DATE: 10.31.2017
TO: ProTrak
FROM: Mitesh Baxi
 Traffic Engineering

■ **TIDEWATER BREWING CO [Plan Review]**

↻ Initial Review Note ↻

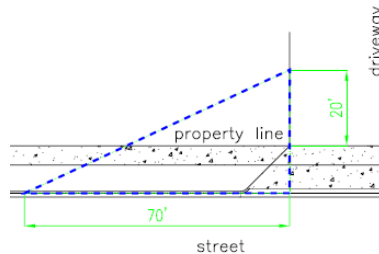
- The site is within 500' of a Traffic Signals. Revise all sheets to accurately illustrate the existing conditions on and surrounding this parcel. Show all adjacent traffic signs, lane configurations, traffic control devices and pavement markings for N 10th St and Market St intersection on the site inventory plan. Please refer to the Technical Standards and Specifications Manual (link is below) Ch. VII C.1.a.2. for specific information and distance requirements. Contact Traffic Engineering at 341-7888 if you need assistance locating these elements.
